# Access Compliance Report

## Public Rights-of-Way

| Intersection ID: 8391                   | Main Street: LASALLE_ST | Cross Street: MADRID_ST                 | Location: SW           |
| ADA ID: 2F4C541B8FEA                    | Ramp Type: PerpDiag     | Initial Pass/Fail: Fail                 | Overall Compliance: No |

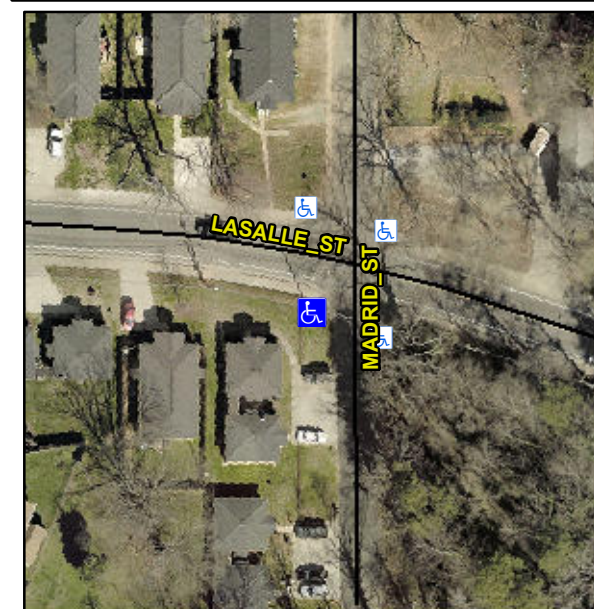
**Not Found, R304.5.1, R304.2.2**

| Compliance | Description           | Data | Compliance | Description                 | Data |
|------------|-----------------------|------|------------|-----------------------------|------|
| N/A        | Ramp Length (in)      | 60.0 | No         | Ramp Slope (%)              | 12.0 |
| No         | Ramp Width (in)       | 34.0 | Yes        | Ramp XSlope (%)             | 1.9  |

**Remove & Replace Curb Ramp With Two New Directional Ramps or Equivalent.**
